August 17, 2017  
GO2-17-147

Subject: **COLUMBIA GENERATING STATION, DOCKET NO. 50-397  
ENERGY NORTHWEST'S NOTIFICATION OF FULL COMPLIANCE WITH  
ORDER EA-12-049, "ORDER MODIFYING LICENSES WITH REGARD TO  
REQUIREMENTS FOR MITIGATION STRATEGIES FOR BEYOND DESIGN  
BASIS EXTERNAL EVENTS"**

<b>Columbia Generating Station  Mitigation Strategies/Spent Fuel Pool Instrumentation Safety Evaluation Audit Items:  Audit Items Currently Under NRC Staff Review, Requiring Licensee Input As Noted</b>		
<b>Audit Item Reference</b>	<b>Item Description</b>	<b>Licensee Input Needed</b>
ISE CI 3.2.3.B	The licensee's proposed strategy for maintaining containment will rely on installation of the HCVS as required by Order EA-13-109. When complete, the licensee's calculations supporting the revised containment response and sequence of events timeline should be reviewed to confirm that the timeline is appropriate and that containment functions will be restored and maintained following an ELAP event.	The licensee needs to provide to the NRC staff the final configuration and calculations for the HCVS.  <b>Energy Northwest Response</b> See attached discussion.
AQ 41	The alternate strategy for Phase 2 core

NO.	DATE	DESCRIPTION
1	1-10-86	ISSUED FOR REVIEW
2	1-10-86	REACTOR BUILDING EL 606'-10 1/2" INSTRUMENT AND CONTROL CONDUIT AND TRAY PLAN

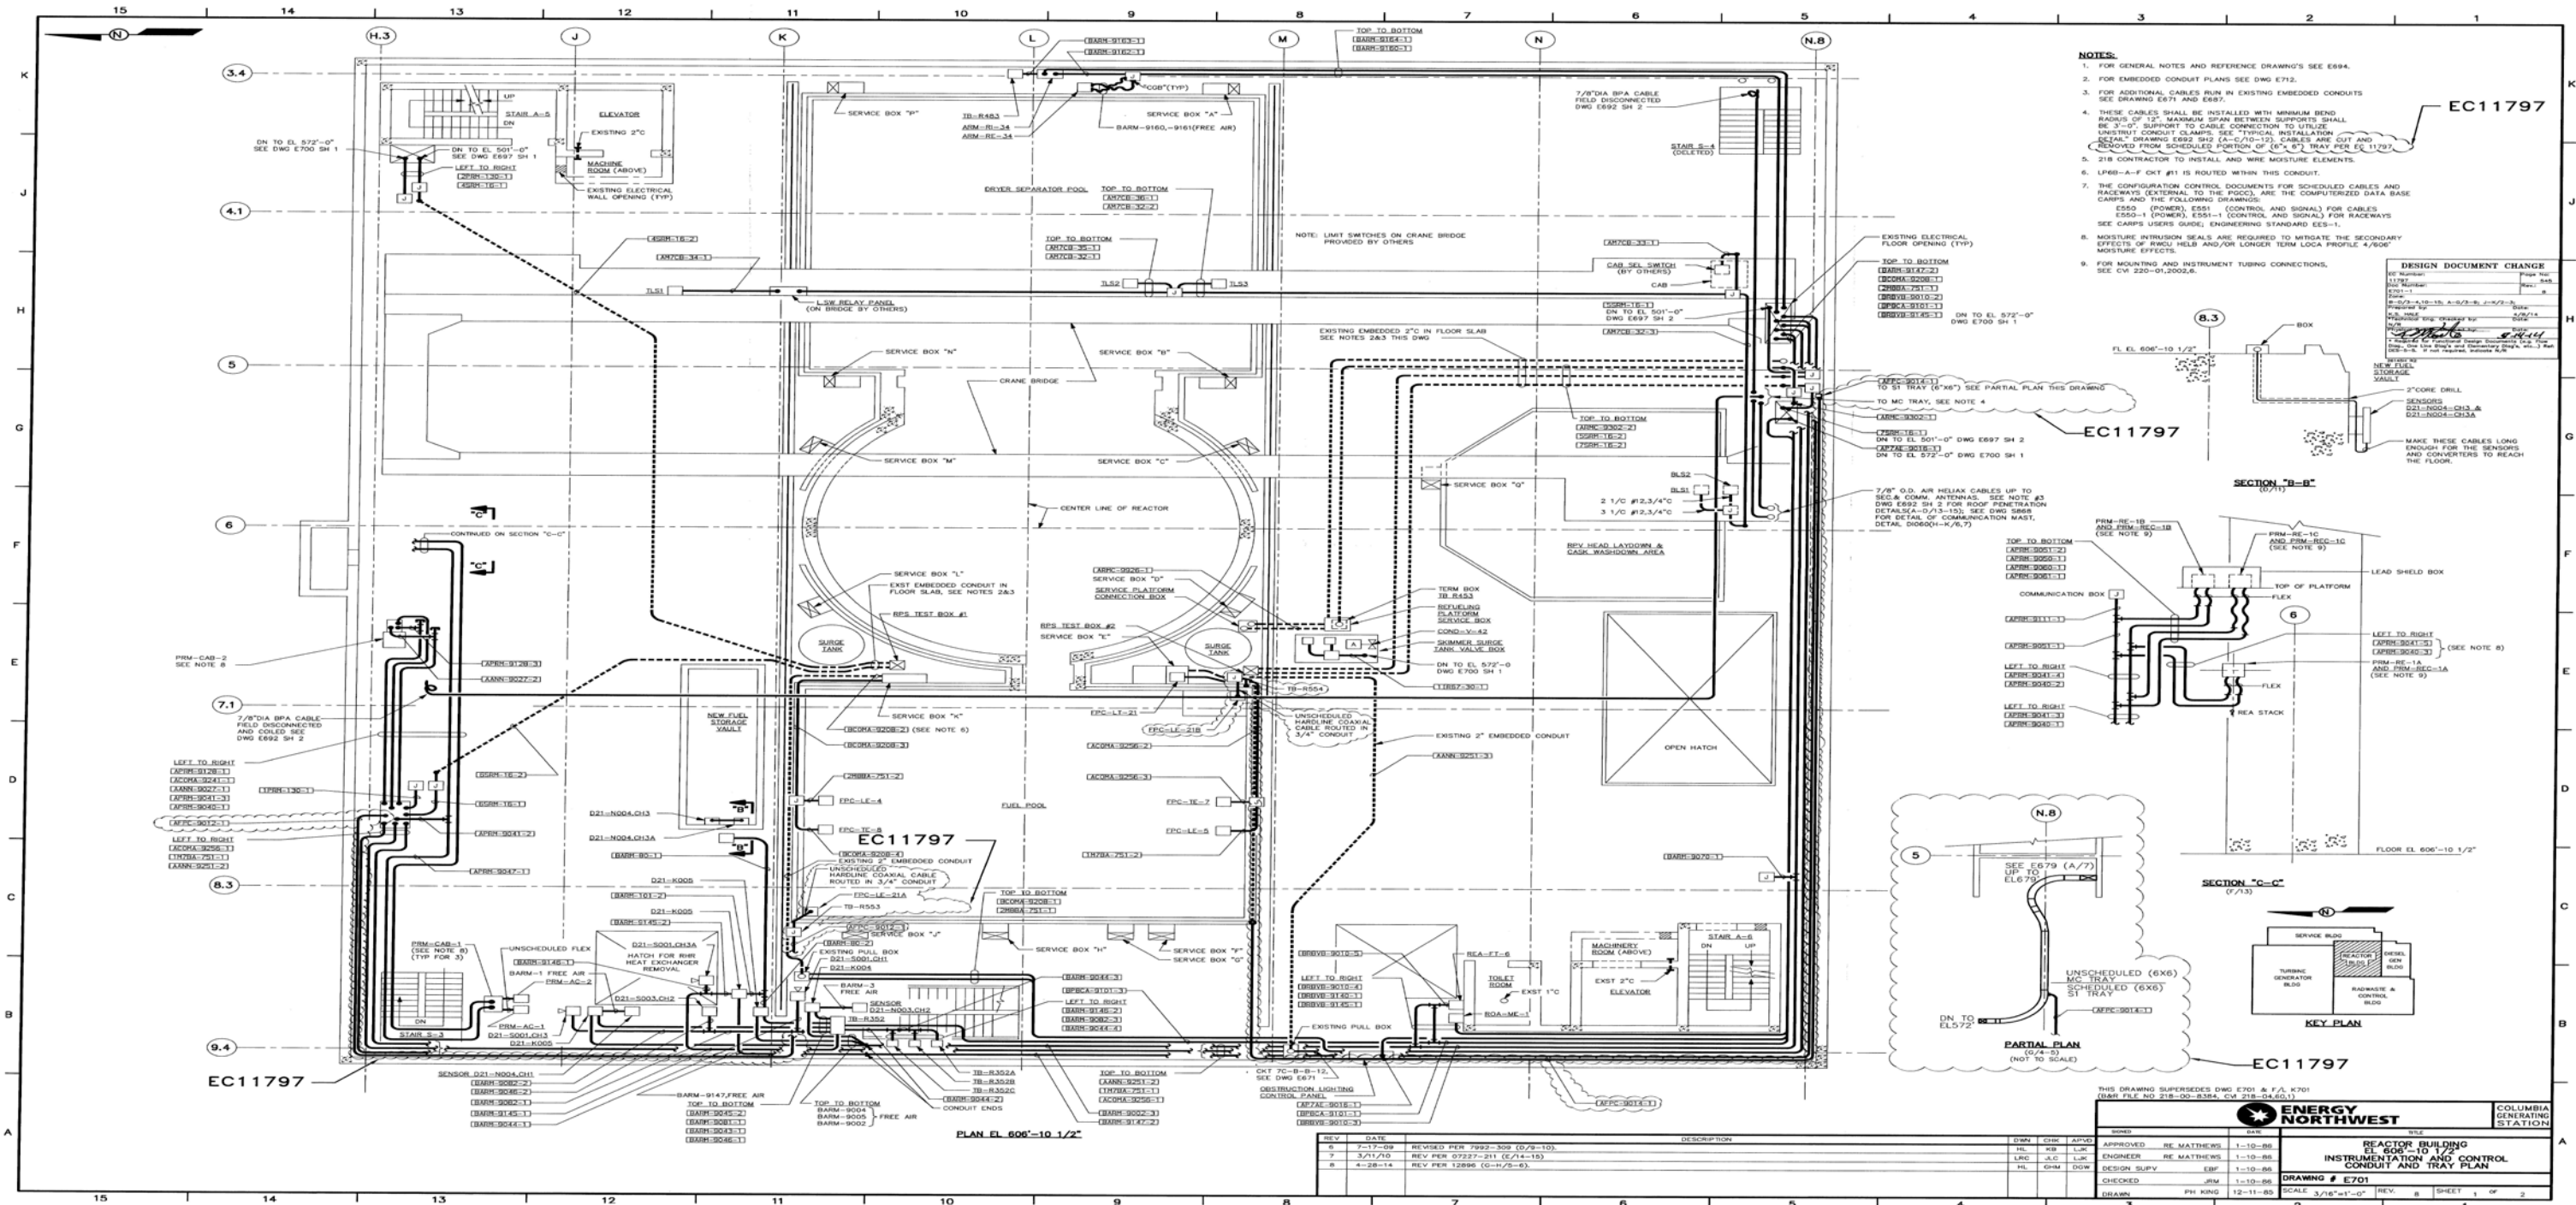
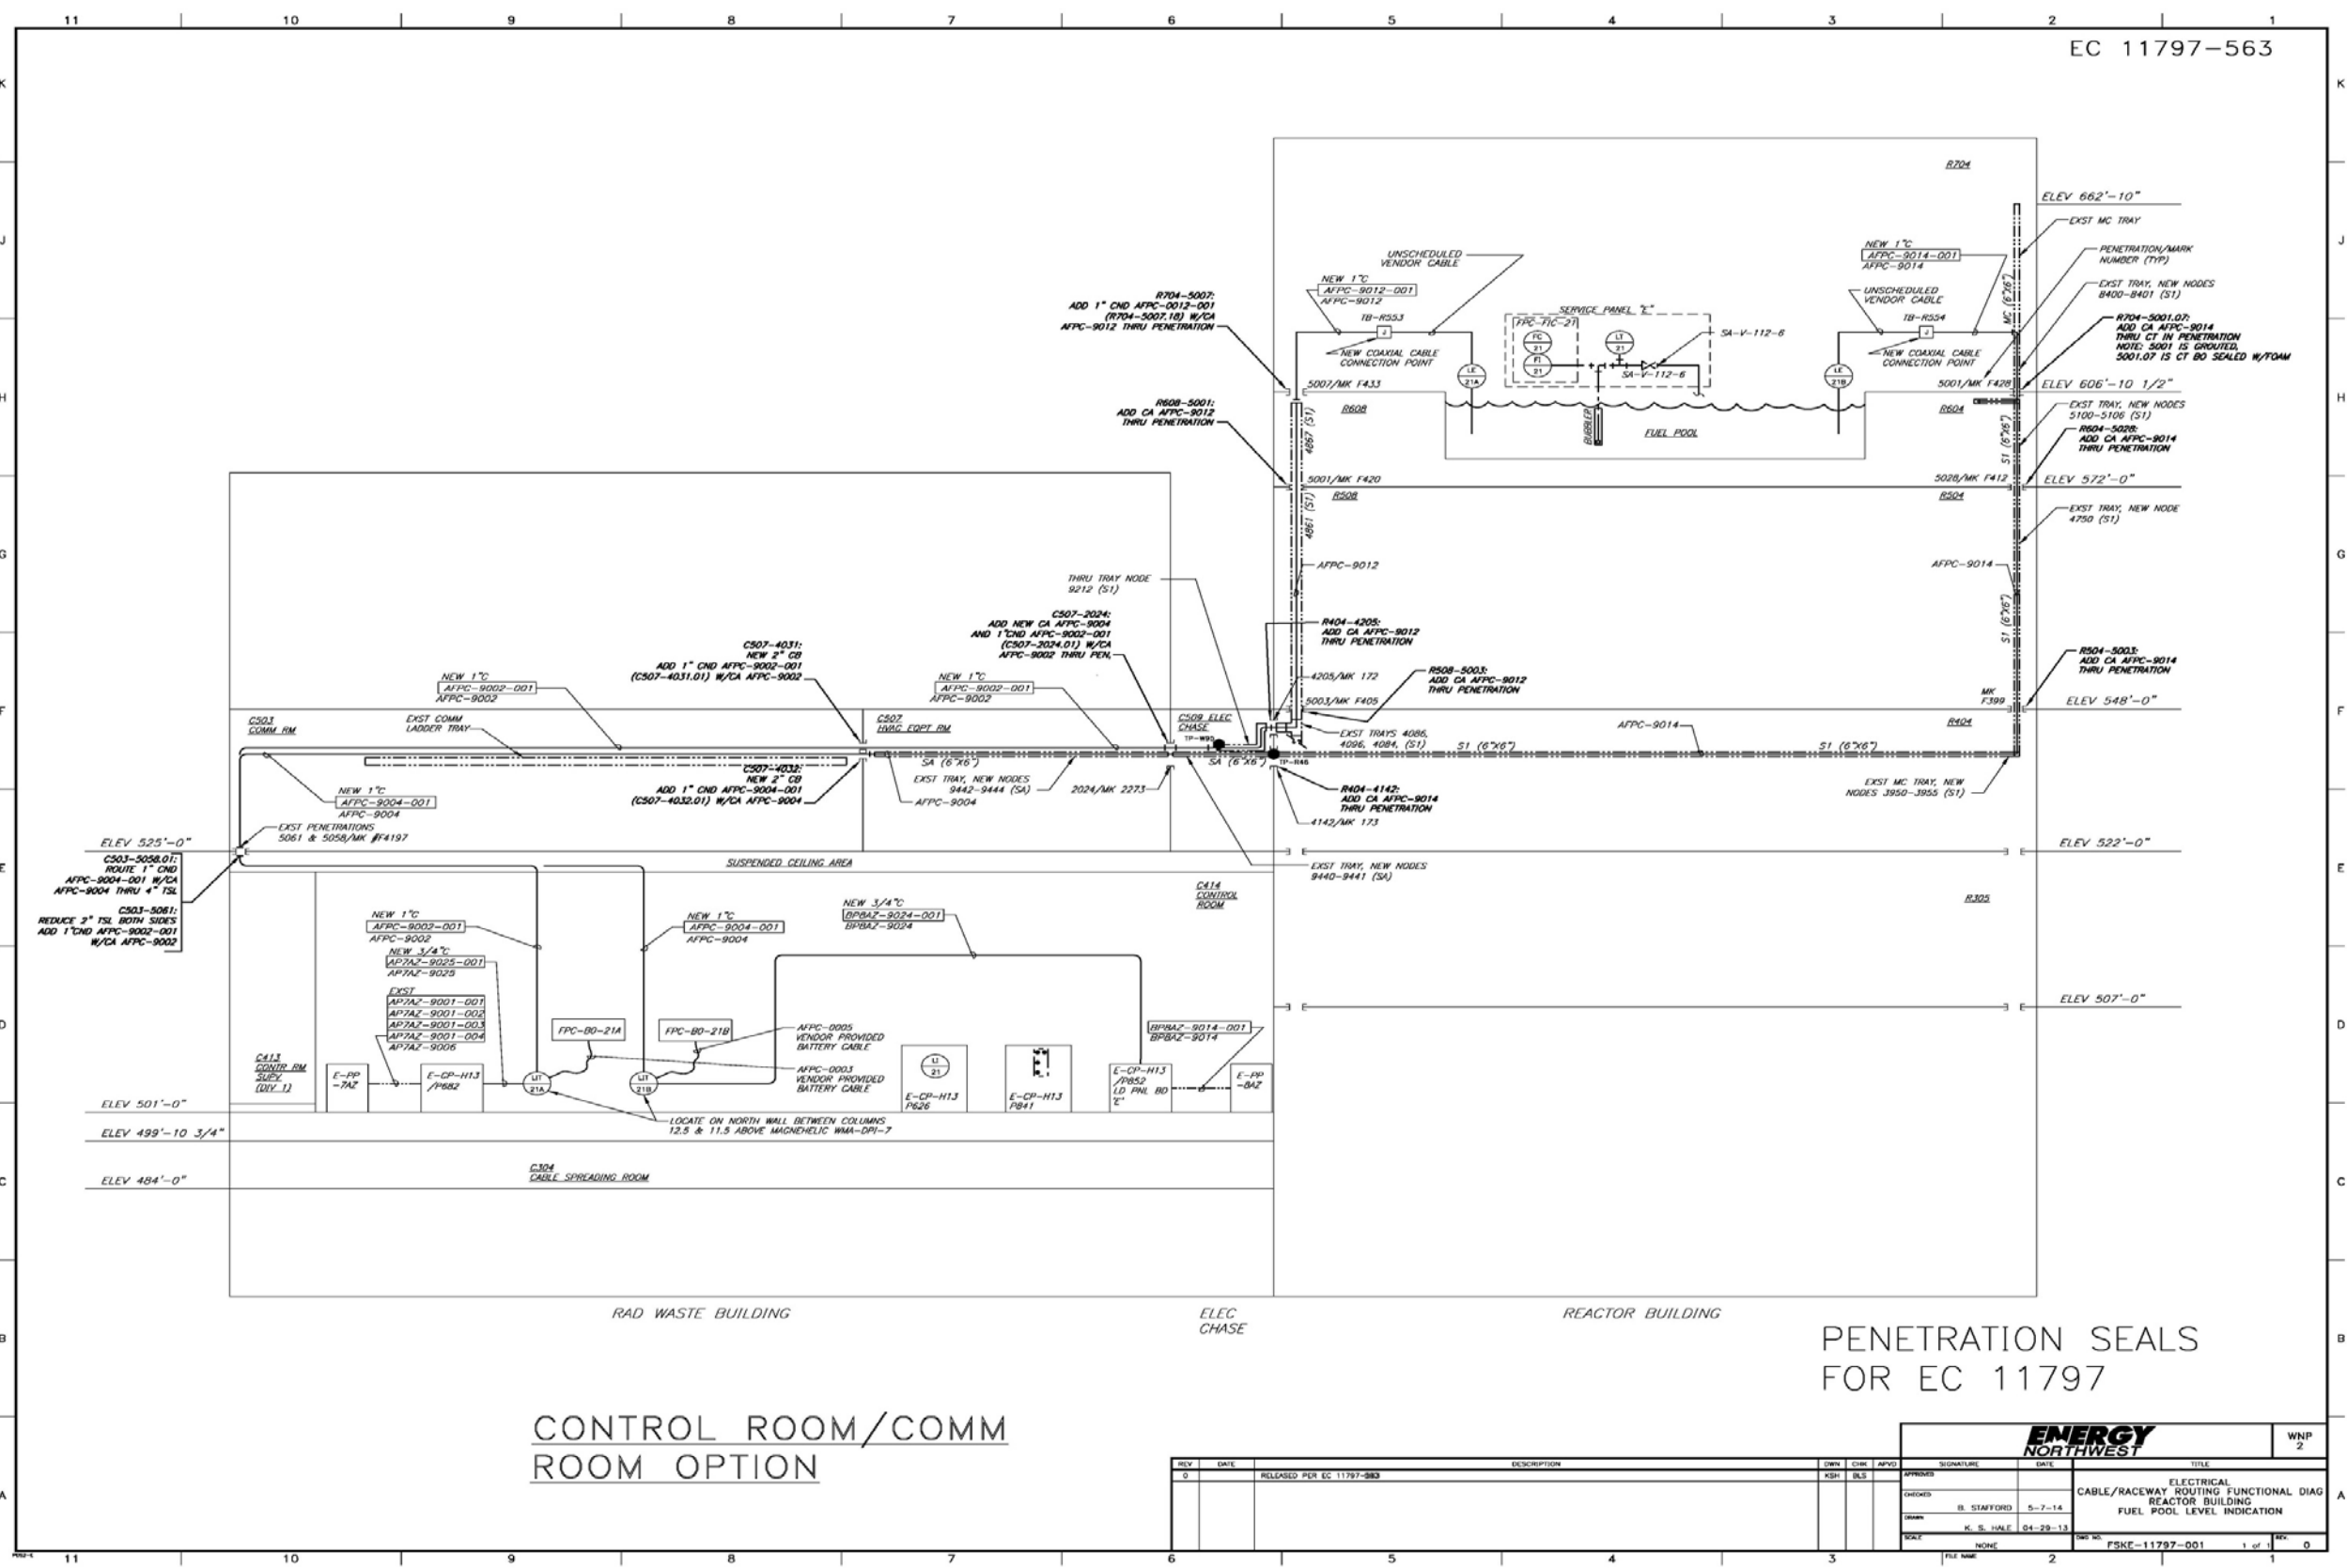
- a) A clearly labeled sketch or marked-up plant drawing of the plan view of the SFP area, depicting the SFP inside dimensions, the planned locations/placement of the primary and back-up SFP level sensor, and the proposed routing of the cables that will extend from the sensors toward the location of the read-out/display device to meet the Order requirement to provide reasonable protection of the level indication function against missiles that may result from damage to the structure over the SFP.
- b) Please address how other hardware stored in the SFP will not create adverse interaction with the fixed instrument location(s).

**Energy Northwest Response**
